07/16/2015

Re: Seminole Electric Cooperative, Inc.
Seminole Generating Station, Putnam County Florida
Power Plant Certification No. PA 78-10
Post-Certification Amendment to Application

Warehouse Parking Lot

RE: Seminole Generating Station (PA 78-10)
Amendment Request (AM12-033)
Sidewalk Addition

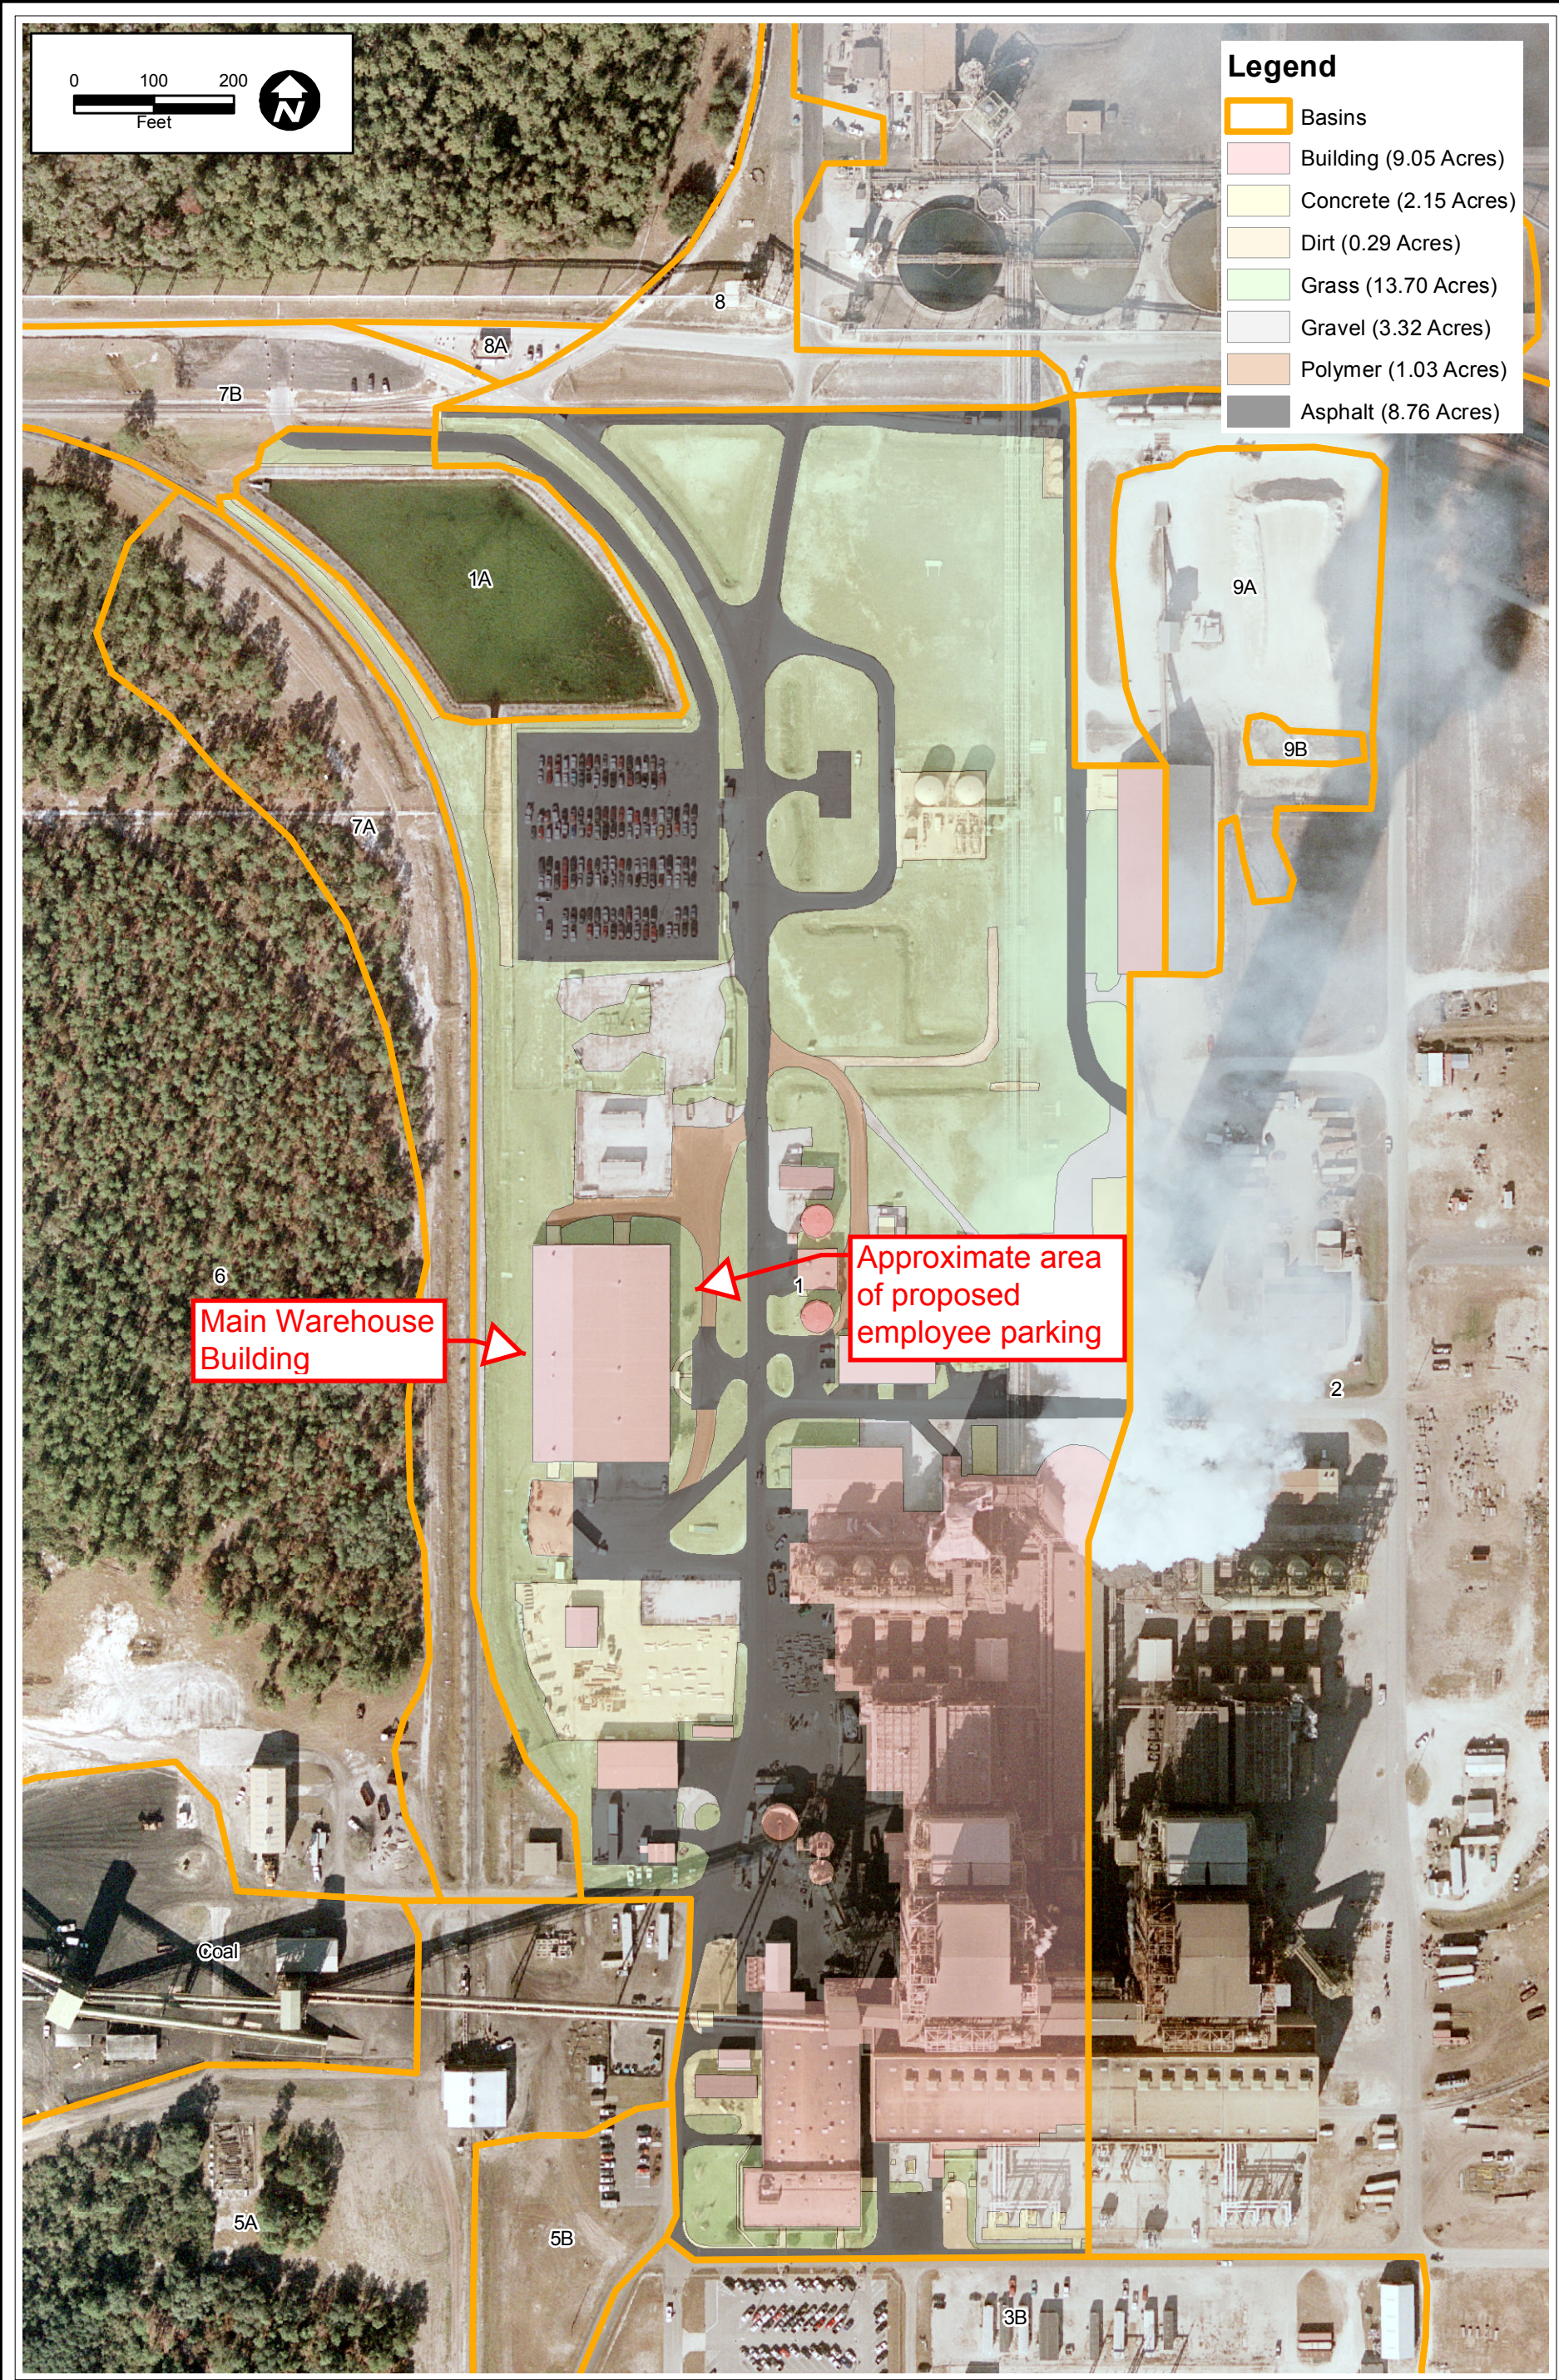
SGS plant staff has expressed the need to create an approximately 20 ft. by 60 ft. employee parking area made of 57 stone in front of the Main Warehouse Building, as there is currently no nearby parking area for warehouse employees. The new parking area will be located within Basin 1 in front of our Main Warehouse Building just north of the current paved entrance loop. The area is currently a grassy area underlain with limerock. The total area of coverage will be approximately 1,200 square feet. Runoff from the additional stone will be minor and drain into Detention Pond #1 within Basin 1.

I have attached a Google Earth location map of the warehouse with the approximate area of the 57 stone outlined in red. Also attached is a copy of the Basin 1 map, as well as a 2012 amendment with modeling information within the same basin. We have made no impervious surface additions within this basin since then. We feel that stormwater pond #1 has sufficient storage and attenuation capacity to accommodate the addition of approximately 1,200 square feet of 57 stone. The last attachment to this letter is email correspondence I had with Junhong Shi, from FDEP Northeast District, agreeing with our assessment.

FIGURE 1.
PROPOSED CONCRETE SIDEWALK

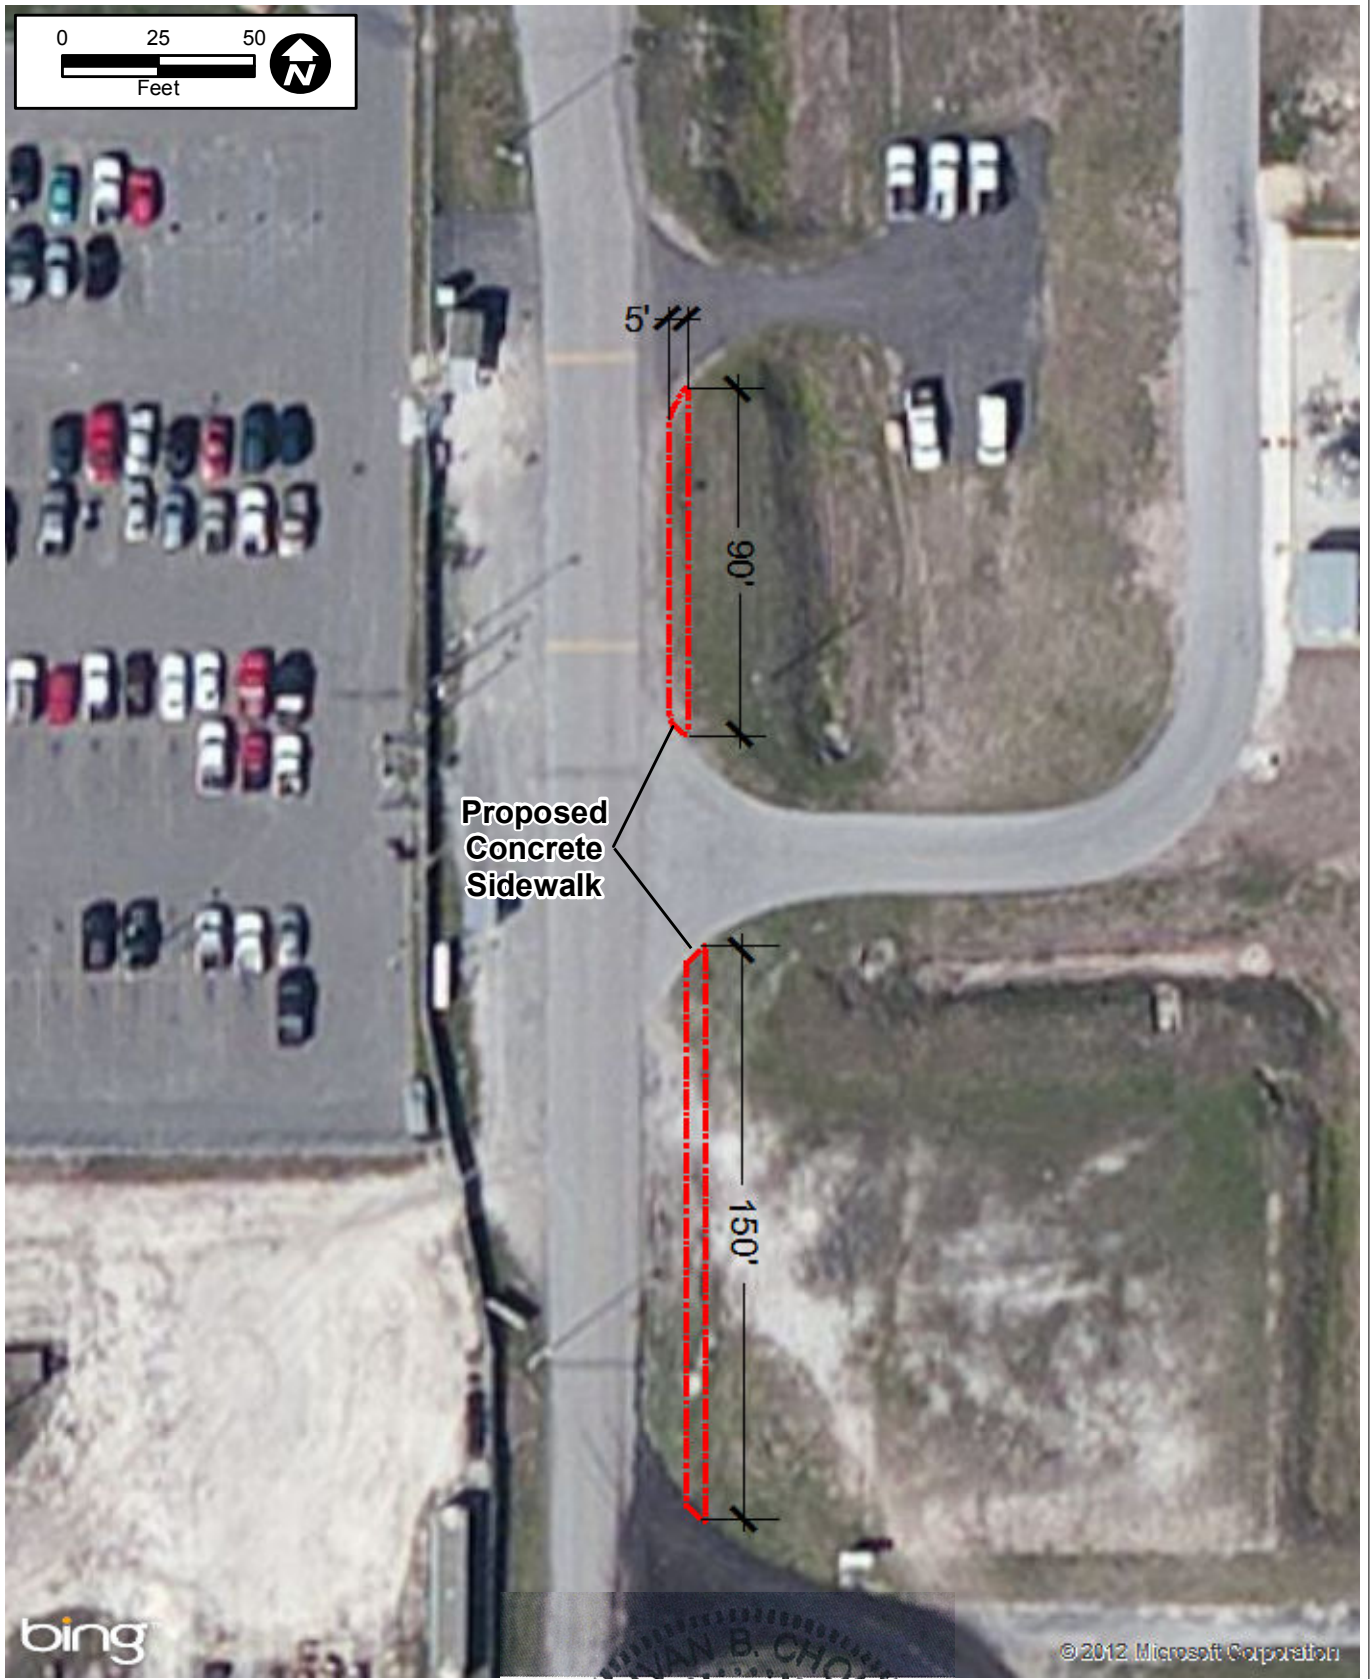
SECI plans to construct two concrete walkways on mostly grassy areas adjacent to the contractor parking lot along the main entrance road. The width of the two sidewalks is 5 feet (ft), and the lengths are 90 and 150 ft, respectively (see Figure 1). The purpose of the concrete sidewalks is to provide walking safety from the parking lot for the contractors and plant personnel. The sidewalk addition will slightly increase the impervious surface area and thus more stormwater runoff to detention pond #1. To assure that the existing pond #1 has sufficient storage capacity to attenuate the runoff from the concrete walkways, ECT conducted a hydraulic/hydrologic analysis as described in the following paragraphs.

FIGURE 2.
SEMINOLE GENERATING STATION STORMWATER BASIN #1 LAND USE
SEMINOLE ELECTRIC COOPERATIVE, INC.

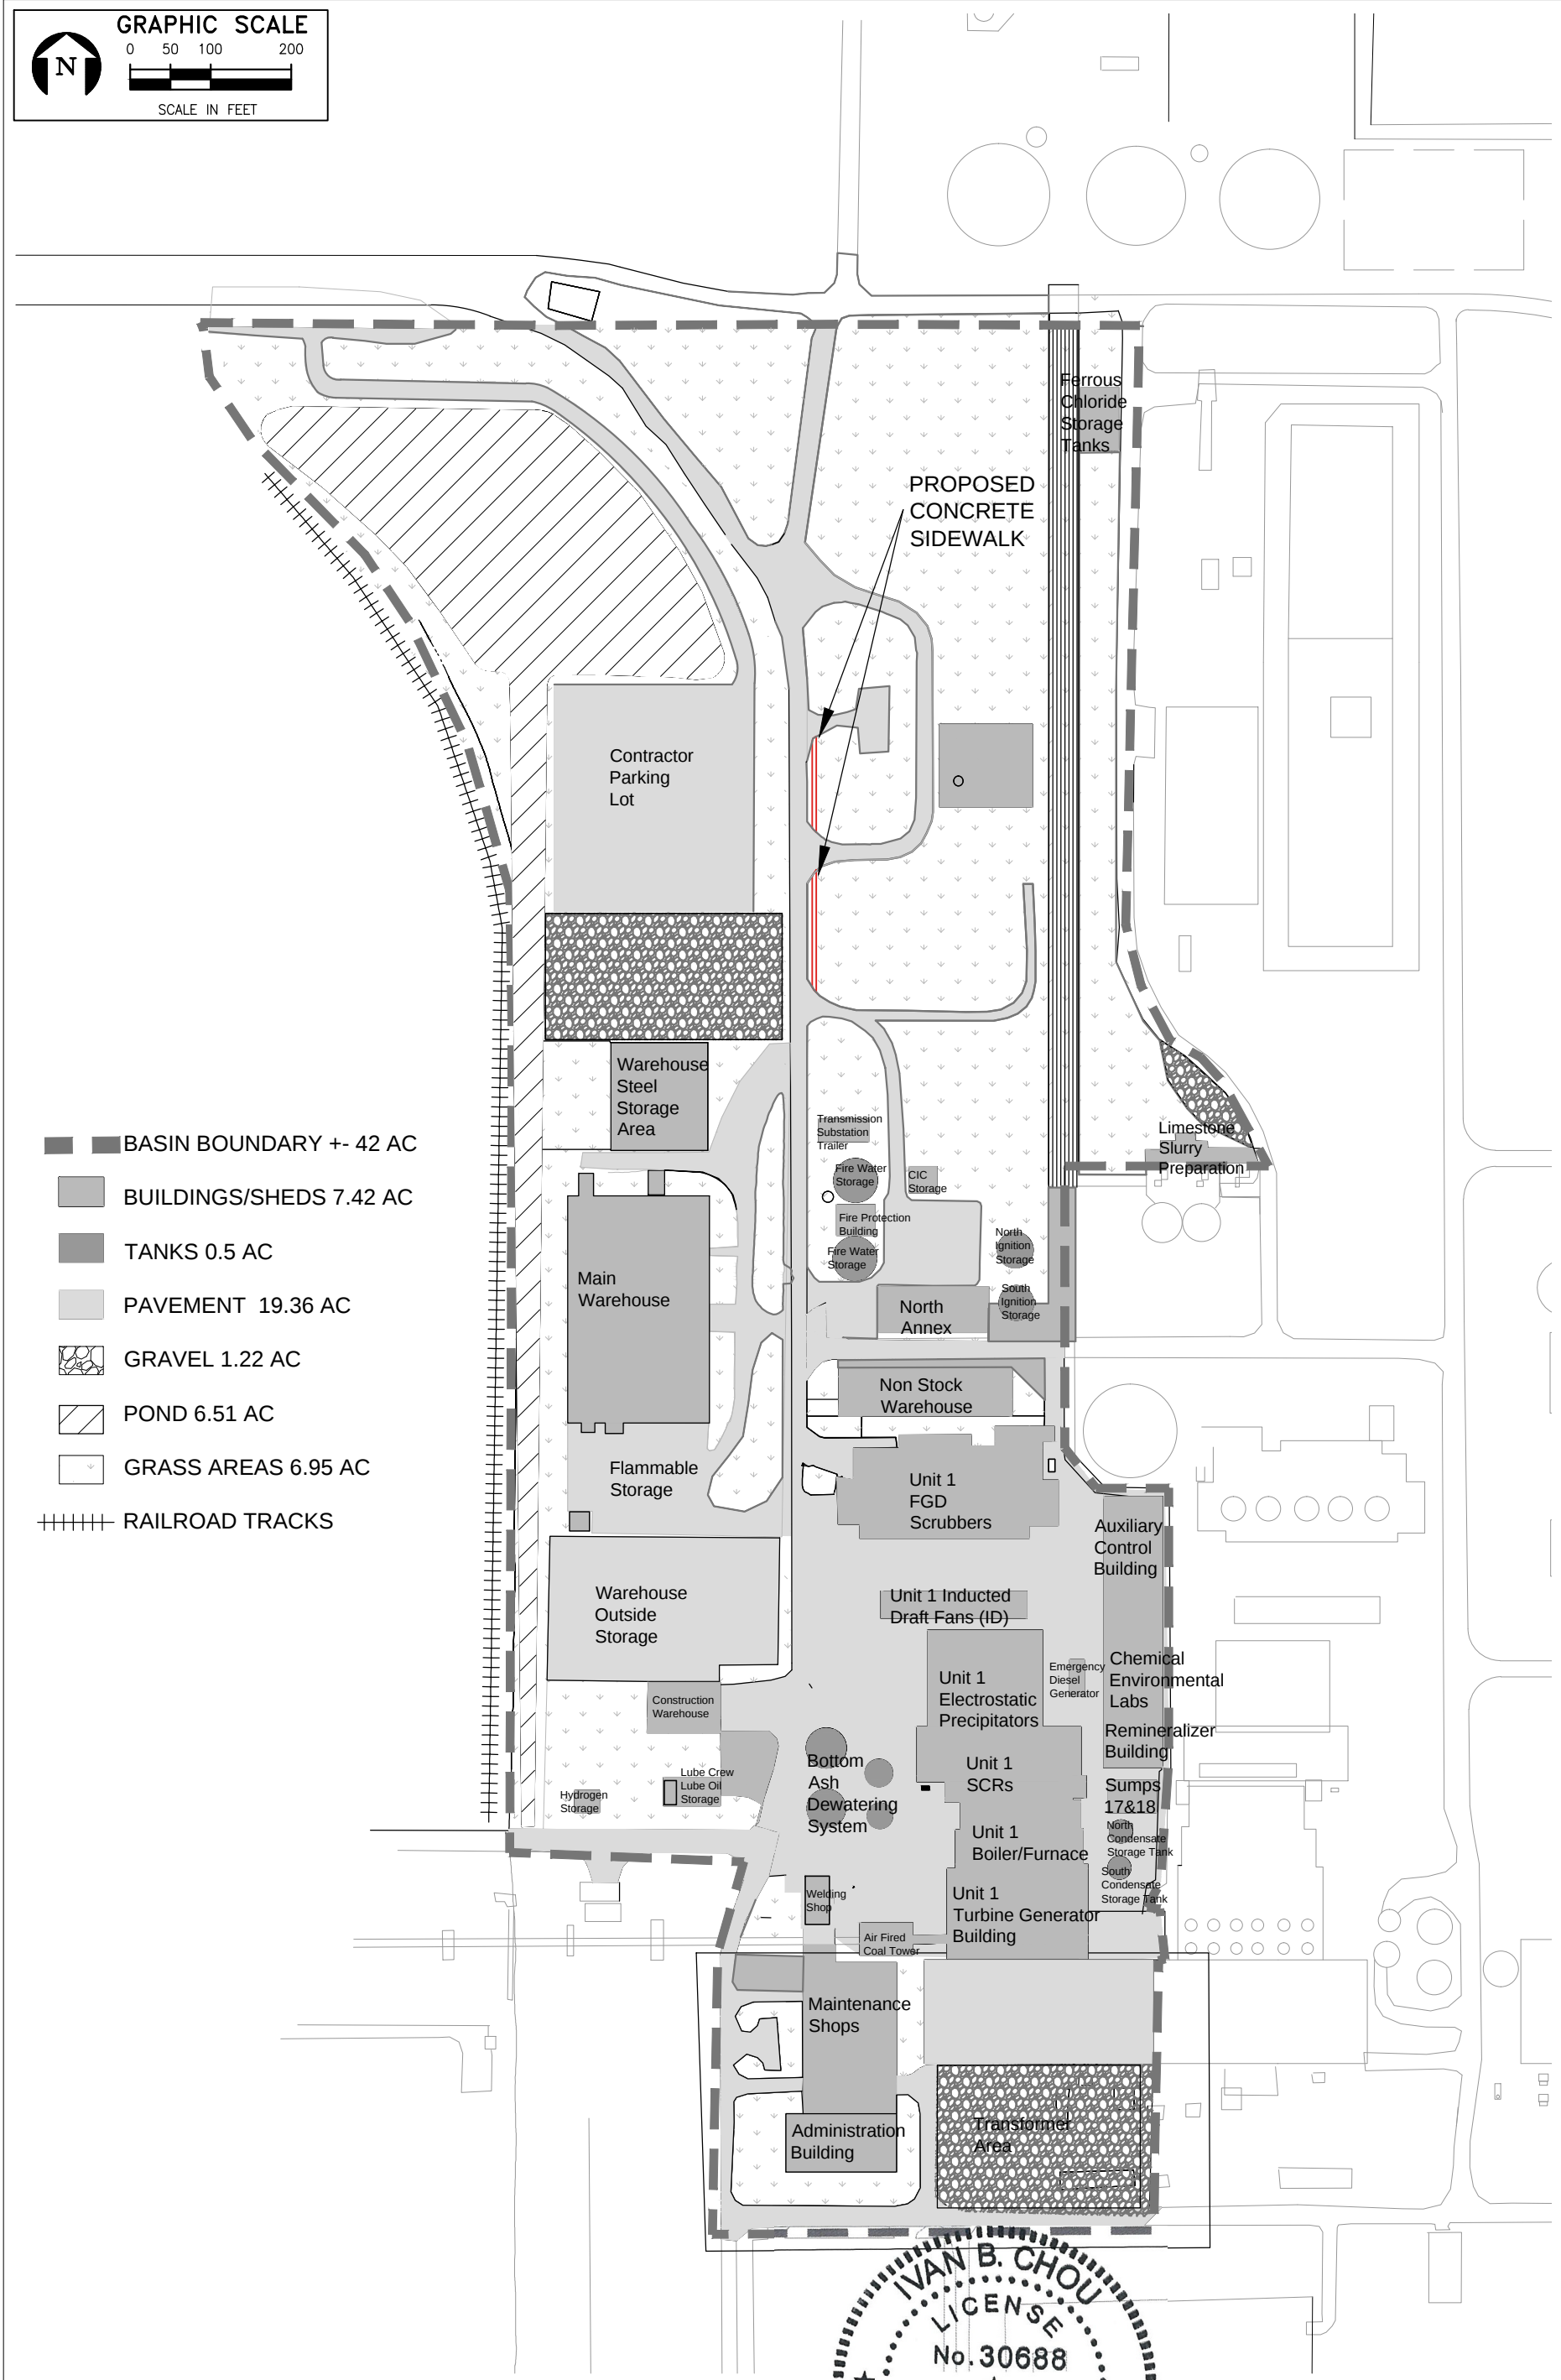
sidewalk conditions. Figure 2 shows the land use information for stormwater basin #1, including the proposed 1,200-ft² concrete sidewalks. Table 2 provides the curve number (CN) calculations for the pre-SCR and post-sidewalk conditions.
